Submission to the Department of
Planning and Infrastructure
Sydney CBD and South East Light Rail Project
(SS1 6042)

Background

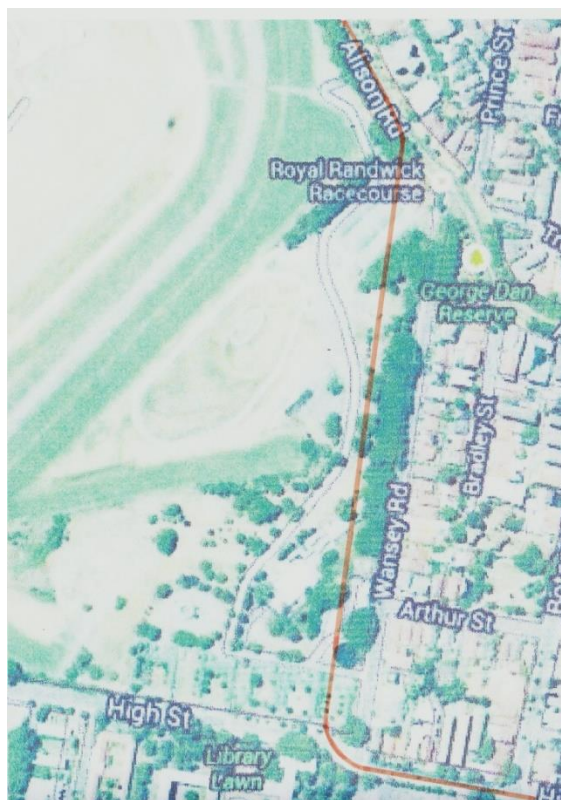
The Wansey Road Action Group (WAG) and Randwick City Council (RCC) have submitted detailed responses to the EIS for the CSELR and it is not our intention to duplicate this work. Our intention is to focus on the relative costs associated with two of options being considered, which are

- The EIS preferred Wansey Rd Alignment.
- The WAG preferred Viaduct option.
